Subject: **Waterloo Metro Quarter OSD**
SSD-10438 Basement – Response to submission comments

Date: 15 February 2021

This note has been prepared to respond to the comments raised by the Environment, Energy and Science Group (EES) to the Department of Planning, Industry and Environment (DPIE) public exhibition for Waterloo Metro Quarter Over Station Development (OSD).

Proposed Scenario - 1% AEP

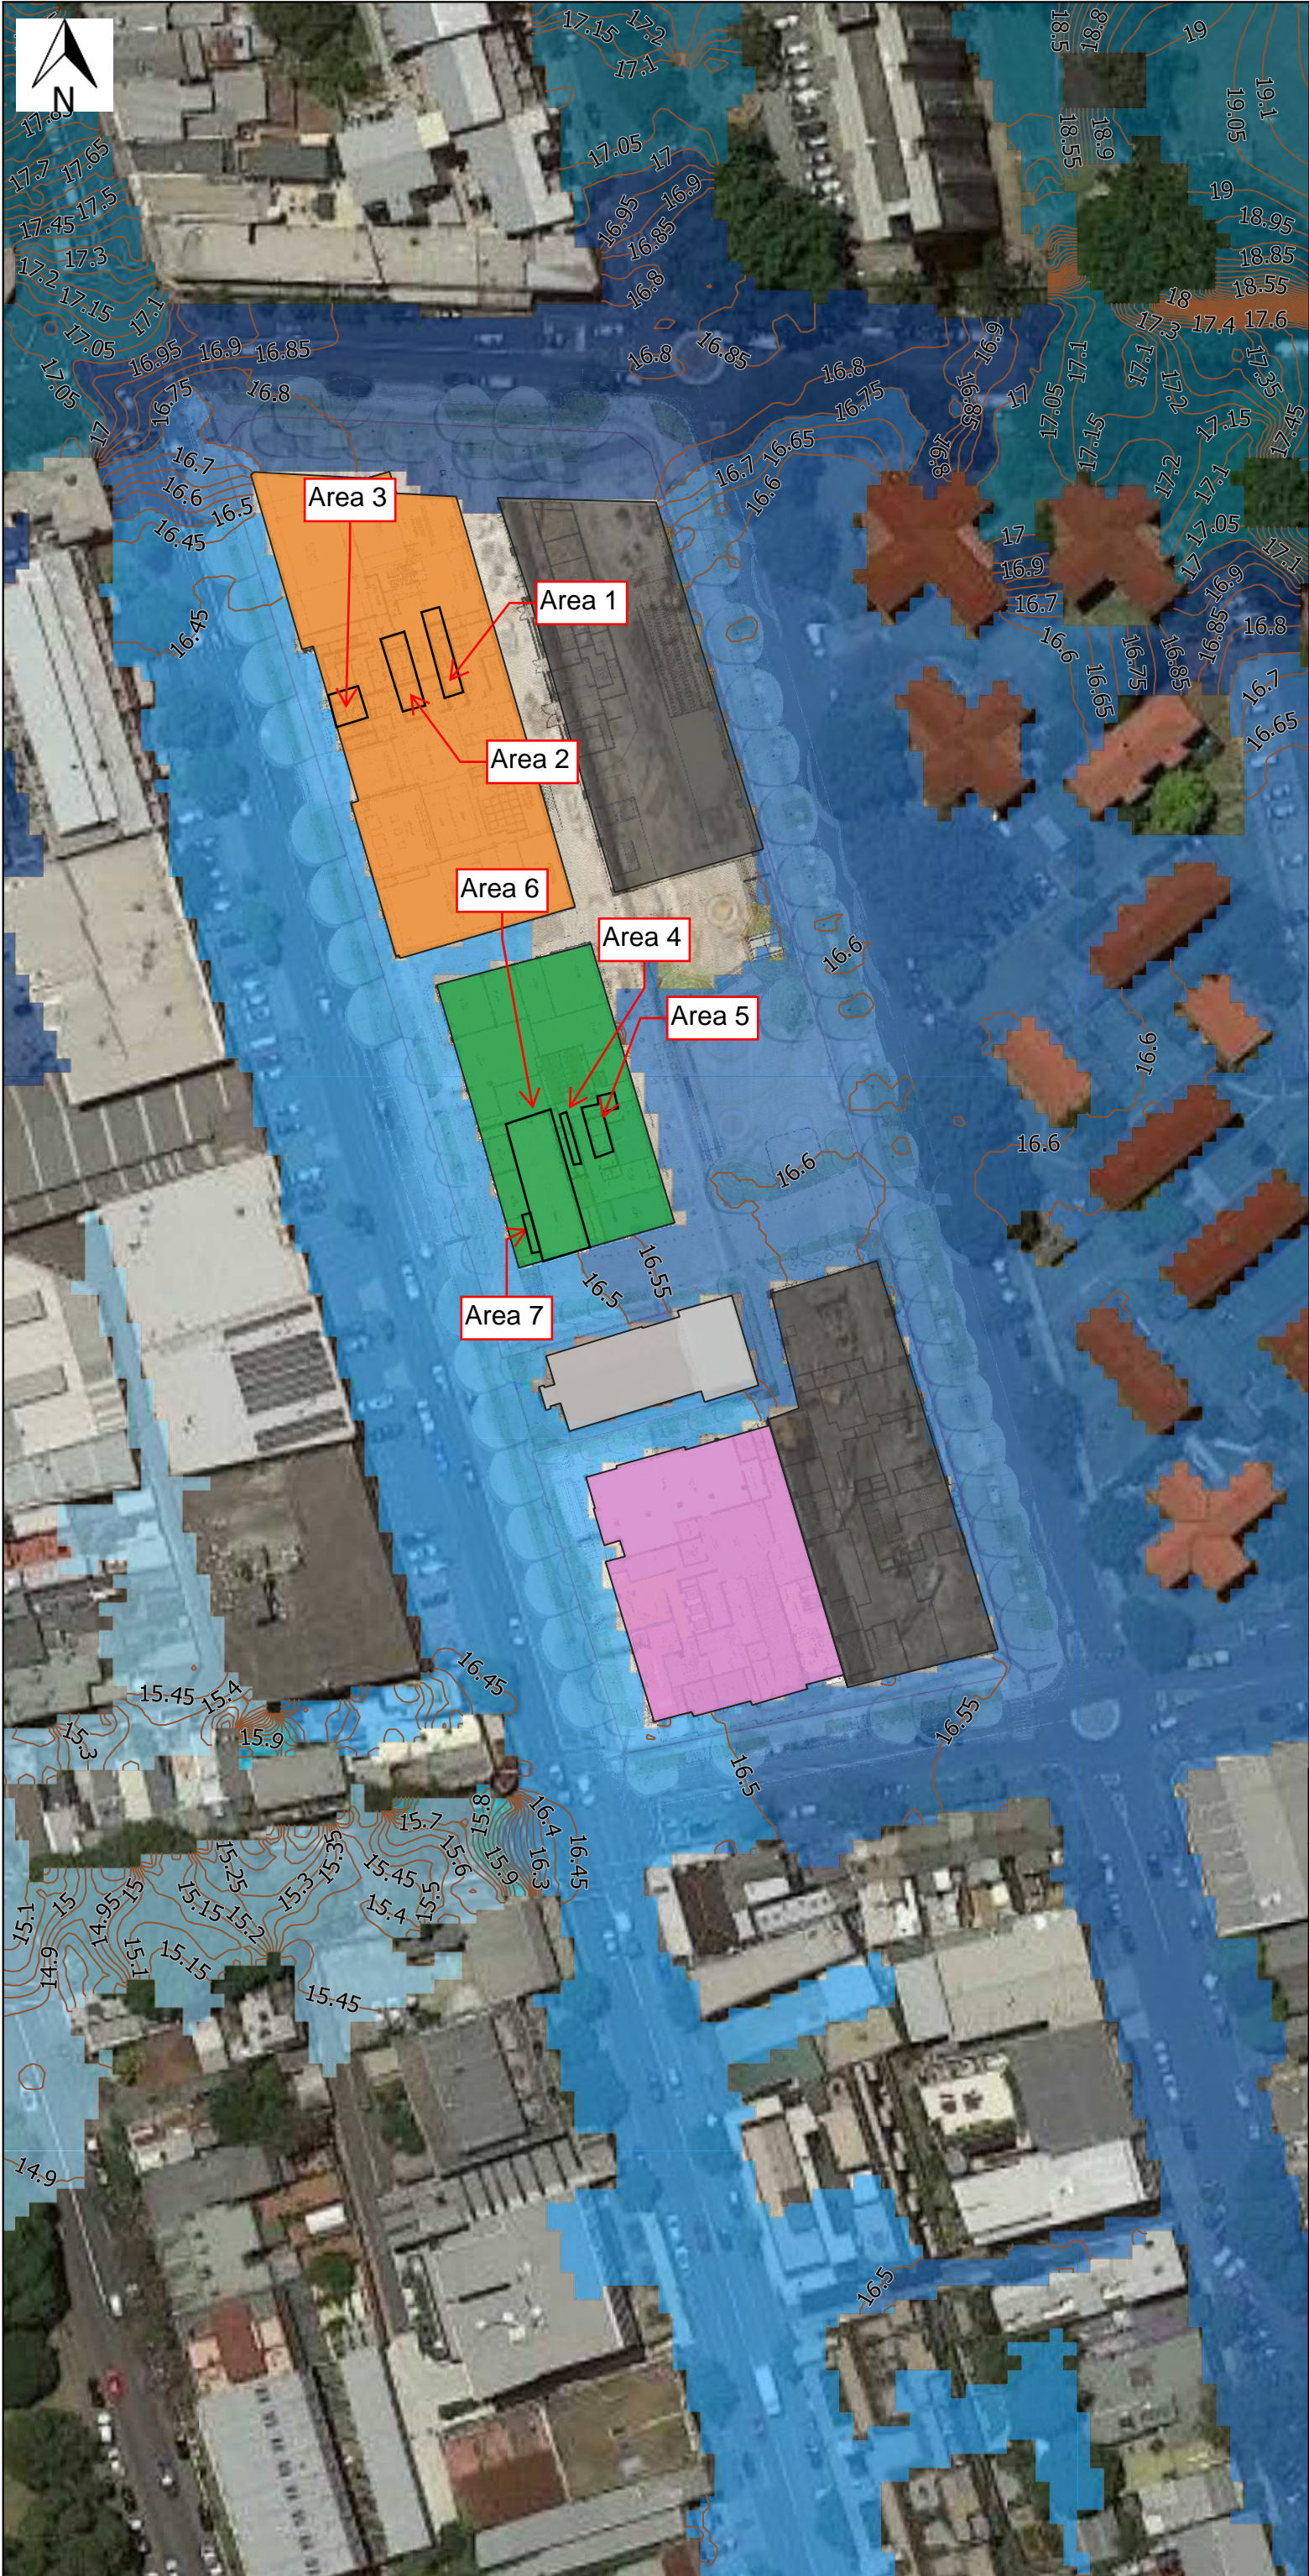
| Comment | | Response |
|--|--|--|
| 1 | The reports have not included flood level mapping for any scenarios, except the 1% AEP flood event plus climate change. Mapping, including water level contours at appropriate intervals, must be provided as a minimum for the 5% and 1% AEP flood events and the PMF event. | Water level contour maps (with a 50mm contour interval) for the 5%AEP, 1% AEP and PMF flood events have been prepared and attached to this response as requested by the EES reviewer. |

BASEMENT - FLOOR PLAN LEVEL 00

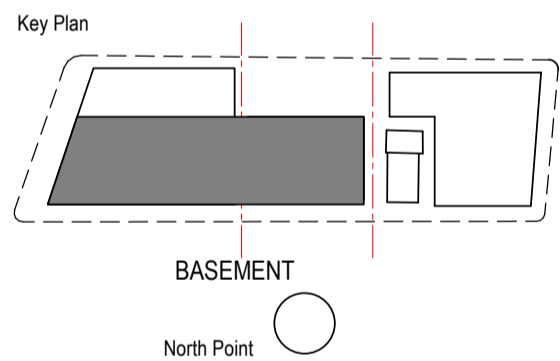
| Comment | | Response |
|--|--|--|
| 3 | <p>Generally, floor levels are above the 1% AEP flood level and generally above the PMF level. Where required at entries to basements, 500 mm freeboard to the 1% AEP flood level appears to have been provided. However, the report has not adequately documented all the proposed finished floor levels (FFLs) to enable their comparison to the proposed FPLs.</p> <p>As a minimum, the FFLs need to be provided in Table 4 alongside the FPLs.</p> | <p>All points of ingress to the basement are at or above the 1% AEP + 500 mm freeboard and PMF flood levels (whichever is higher).</p> <p>Please refer to Appendix B of this response for further details on finish floor levels.</p> |

Table 1: Finish Floor Levels (access to the basement)

| Area | Classification | Flood Level as per hydraulic model results (m AHD) | Proposed Floor Level (m AHD) for relevant points of ingress to the basement | Compliant |
|------|---|--|---|--|
| 1 | Access to the underground car park from Northern Precinct | PMF = 16.80 1% AEP + 500mm= 17.115 | 17.13 | Yes. Finish floor level above PMF and 1% AEP+500mm flood level. |
| 2 | Access to the underground car park from Northern Precinct | From Raglan Street PMF = 16.80 1% AEP + 500mm= 17.115 From Botany Road PMF = 16.453 1% AEP + 500mm= 16.646 | 17.13 (protecting flooding from Raglan Street) 16.7 (protecting flooding from Botany Road) | Yes Finish floor level above PMF and 1% AEP+500mm flood level. |
| 3 | Access to the underground car park from Northern Precinct | PMF = 16.462 1% AEP + 500mm= 16.543 | 16.55 | Yes Finish floor level above PMF and 1% AEP+500mm flood level. |
| 4 | Access to the underground car park from Central Precinct | PMF = 16.598 1% AEP +500mm=16.249 | 16.72 | Yes Finish floor level above PMF and 1% AEP+500mm flood level. |
| 5 | Access to the underground car park from Central Precinct | PMF = 16.598 1% AEP +500mm=16.249 | 16.72 | Yes Finish floor level above PMF and 1% AEP+500mm flood level. |
| 6 | Access to the underground car park from Central Precinct | PMF = 16.56 1% AEP +500mm=16.249 | 16.58 | Yes Finish floor level above PMF and 1% AEP+500mm flood level. |

| Area | Classification | Flood Level as per hydraulic model results (m AHD) | Proposed Floor Level (m AHD) for relevant points of ingress to the basement | Compliant |
|------|--|--|---|---|
| 7 | Access to the underground car park from Central Precinct | PMF = 16.56 1% AEP +500mm=16.249 | 16.58 | Yes Finish floor level above PMF and 1% AEP+500mm flood level. |
